SITE-SPECIFIC FLOOD RISK ASSESSMENT

A PROPOSED STRATEGIC HOUSING DEVELOPMENT

BALLYMANY ROAD, NEWBRIDGE, CO. KILDARE

6.0 RESPONSE TO THE WATER SERVICES PLANNING SECTION COMMENTS CONTAINED IN THE KILDARE COUNTY COUNCIL SECTION 6(4)(B) REPORT

Figure 4.1: Extract from the OPW PFRA Map for the area;

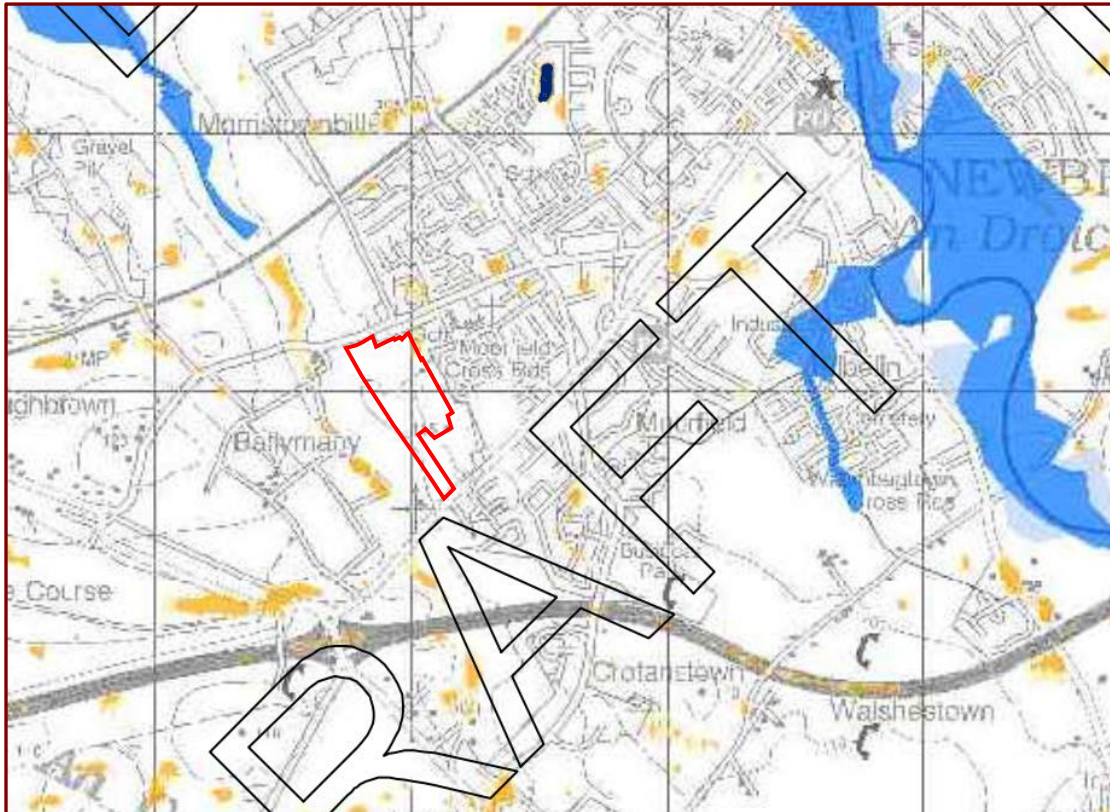
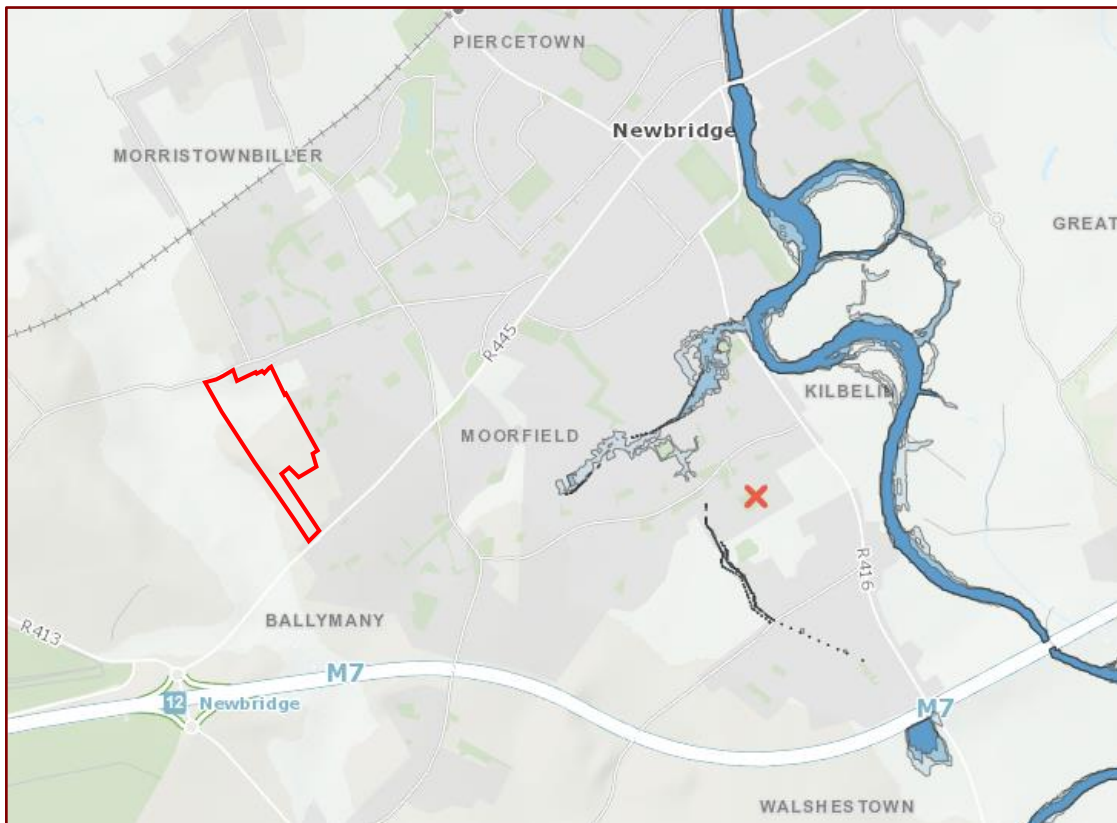
Any loss of on-site flood storage zones identified on OPW PFRA flood mapping as a result of the proposed development will require the provision of an equivalent volume of compensatory flood storage within the boundaries of the subject site: The OPW PFRA map and the CFRAM map for the site (refer to Figures 4.1 and 4.2 presented above) does not indicate any flooding on the site of the proposed development. Thus, no compensatory storage is required or proposed for the site.
